PARTS LIST FOR MODEL SSV4500

Penn Reel Parts list for Model: SSV4500 Spinfisher V

MRP Ver 032924 (Parts List updated to clarify housing/gearing design changes sizing)

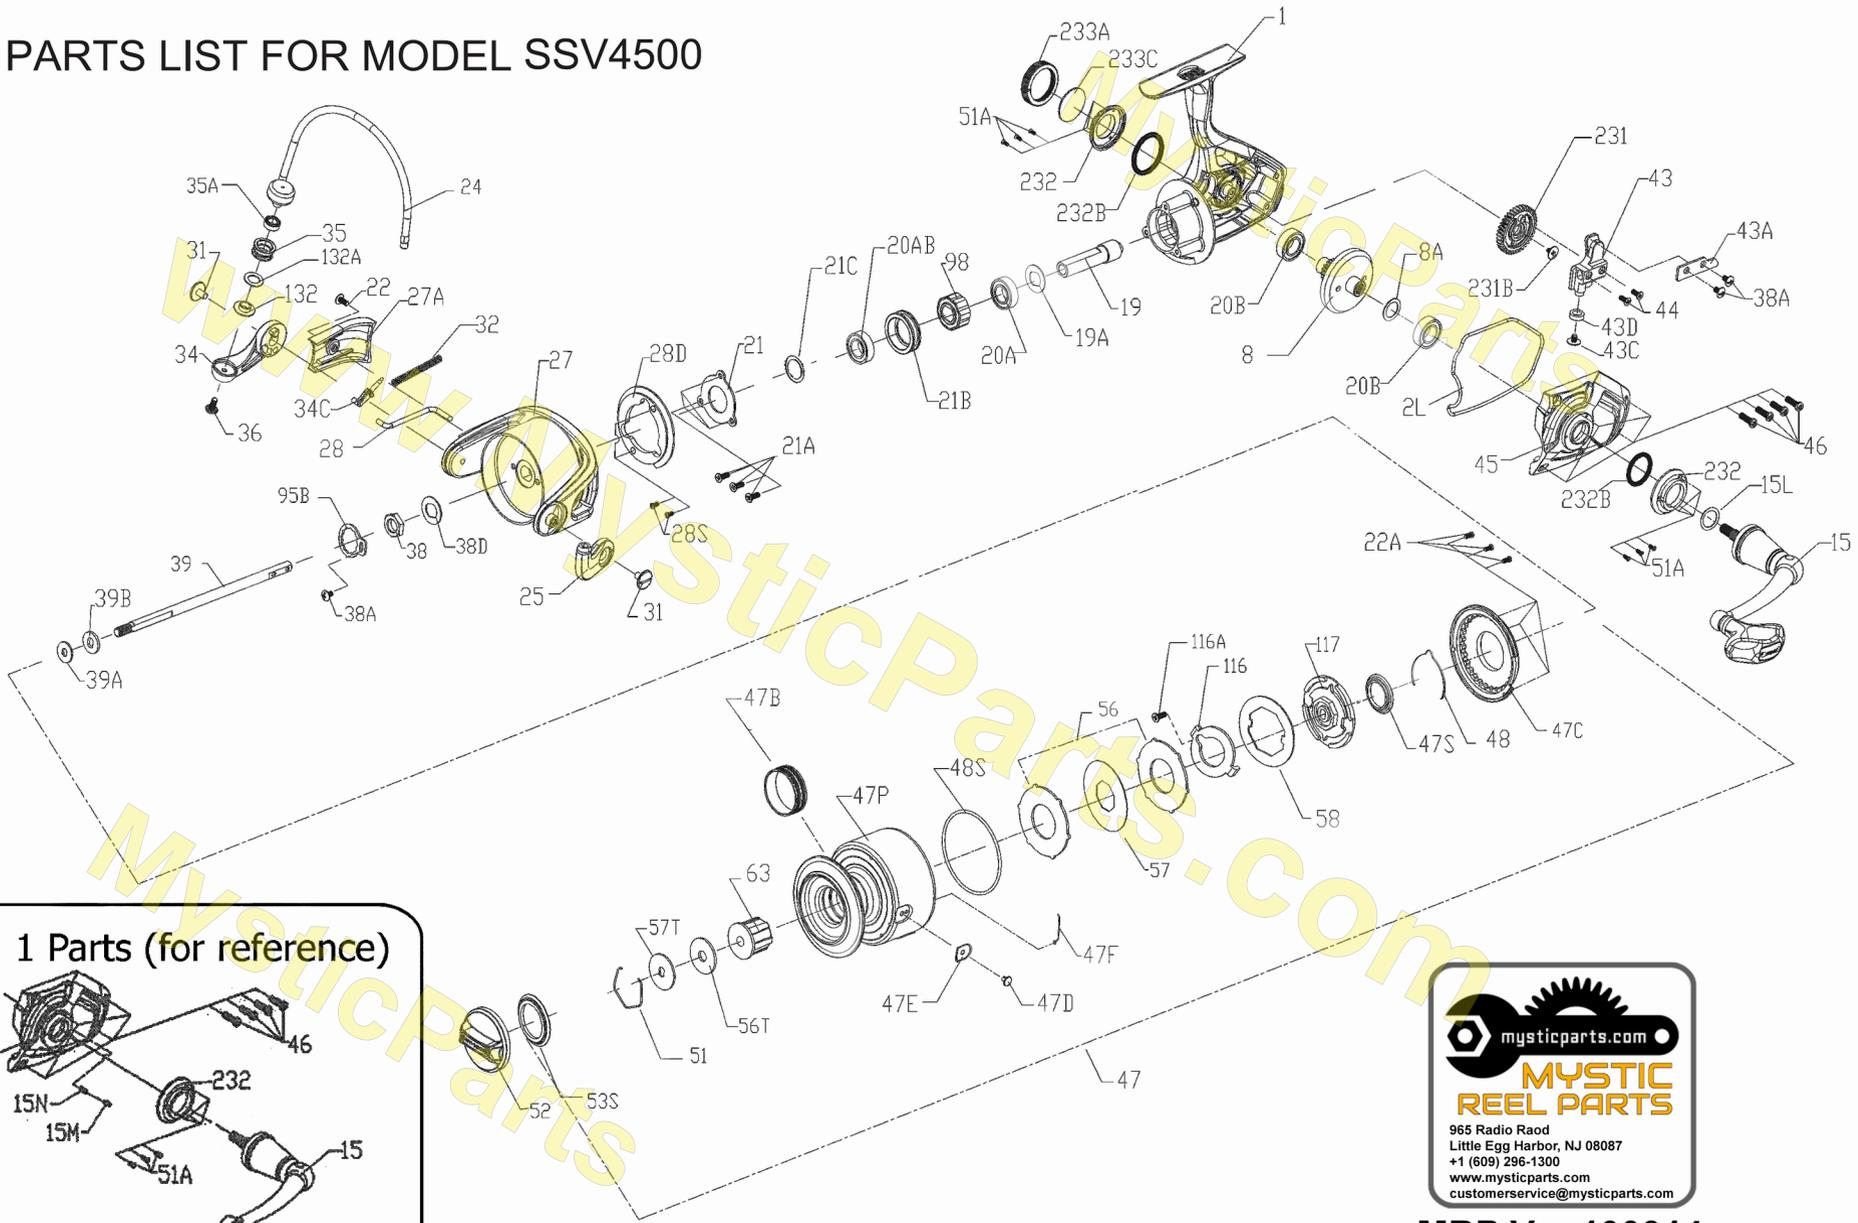
Rev. 4 CHANGED BEARING INFORMATION ----- >

20A	1276924	20A-SSV3500 BALL BEARING (2 REQUIRED)
		THIS WAS UPPER AND LOWER PINION BEARING
20B	1192619	20B-3000SG BALL BEARING (2 REQUIRED)

We are assuming there were errors with the bearing part numbers on the schematic, rather than that they actually changed the bearings.

Revision 6 Bearings

20A	1276924	20A-SSV3500	BALL BEARING
20AB	1308051	20A-CFT3000	UPPER PINION BALL BEARING
20B	1317496	20B-SSV3500	BALL BEARING (2 REQUIRED)

DRAG KNOB SEAL ISSUE on SSV4500 and SSV4500LL reels

52	1276960	52-SSV3500	DRAG KNOB ASSEMBLY Sold by Penn w/Seal 53S-SSV3500 included
53S	1293252	53S-SSV5500	Actual DRAG KNOB SEAL that is on the SSV4500 and SSV4500LL reels

(ERROR Penns schematics list the 53S-SSV3500 which is the smaller seal NOT used on these models)
So if you want the correct size seal you need to order that part separately

******* DESIGN CHANGE WARNING *******

Early SSV reels when released had a slightly different housing, crosswind gear and housing cover

The diameter of the CW gear hole and post was CHANGED and the pin/pin hole diameters on the 45- cover were changed as well

THIS DESIGN CHANGE affects the housing, crosswind gear, and housing cover

RECOMMEND TO USE THE REVISION 6 NUMBERS

MEASURE YOUR HOUSING/GEAR

MEASURE and CHECK STOCK FIRST! .23 peg (1/4") SIZE

1	1276974	1-SSV4500	HOUSING, BODY ASSEMBLY
231	1276987	231-SSV4500	CROSSWIND OSCILLATION GEAR 0.23" I.D. (1/4")
45	1276981	45-SSV4500	HOUSING / BODY COVER to match (1/4")
231B	1307857	231B-SSV3500	CROSSWIND OSCILLATION GEAR SCREW (1/4")

MEASURE and CHECK STOCK FIRST! .309 peg (5/16")

1	NLA **	1-SSV4500	HOUSING, BODY ASSEMBLY with .309 peg (5/16")
231	NLA **	231-SSV4500	CROSSWIND OSCILLATION GEAR 1st run 0.309" I.D. (5/16")
45	NLA **	45-SSV4500	HOUSING / BODY COVER to match (5/16")
231B	1277100	231B-SSV5500	CROSSWIND OSCILLATION GEAR SCREW (5/16")
